## BULLETING

ISO/TS16949 REGISTERED TB-035 • March 2005

## **Bracket Pins**

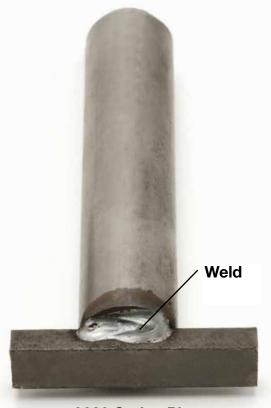
No-Slack® and No-Slack® series fifth wheels use the same bracket pin. The new forged pin is 5-1/4 inches in length and has a one-piece construction with no weld to the head of the pin. This new pin also has an offset head as shown bottom left. The part number for the universal bracket pin is PIN-191P. The pins will take the place of the PIN-135P and PIN-135-1P.

This new pin is offered in a kit form – part # is KIT-PIN-191. This kit takes the place of KIT-PIN-135, KIT-PIN-6000, KIT-PIN-UNVL.

The 3000 Series pin (bottom right) is two piece construction and welded at the head of the pin. The part number for the 3000 bracket pin is PIN-3000. This new pin is offered in a kit form – part # is KIT-PIN-3000.

No-Slack® & No-Slack® Pin Order: KIT-PIN-191P 1 piece construction

3000 Series Pin Order: KIT-PIN-3000 2 piece welded construction
